IRON GATES RESIDENTIAL DEVELOPMENT

Engineering Services and Civil Infrastructure Report

Revised Engineering Services and Civil Infrastructure Report

Report No F0002-AA007094-AAR

Figure 2- Typical Infiltration Strategy

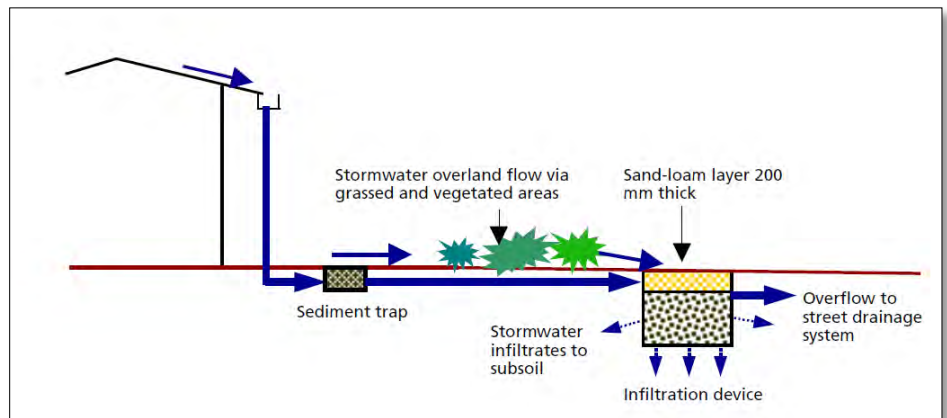
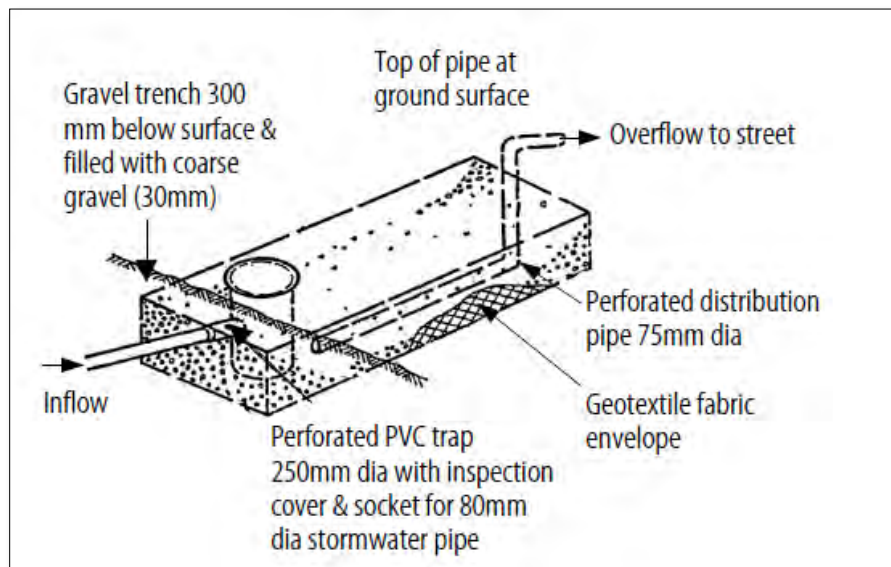
How is overflow from the pits to be managed without causing nuisance stormwater flows to adjoining land owners. Council preference is for the overflow to be discharged to street kerb or via Internal Allotment Drainage (IAD).

Flows will be captured and conveyed to the infiltration system, with overflow being directed to the street kerb system. Refer figures 4 and 5 below shows a typical infiltration system details. It should also be noted that all proposed lots typically fall to the road with no inter allotment needed.

- How are the pits be protected from future owners constructing over the pits or reducing the effectiveness of the pit. An easement on title may be an appropriate method to protect this infrastructure.
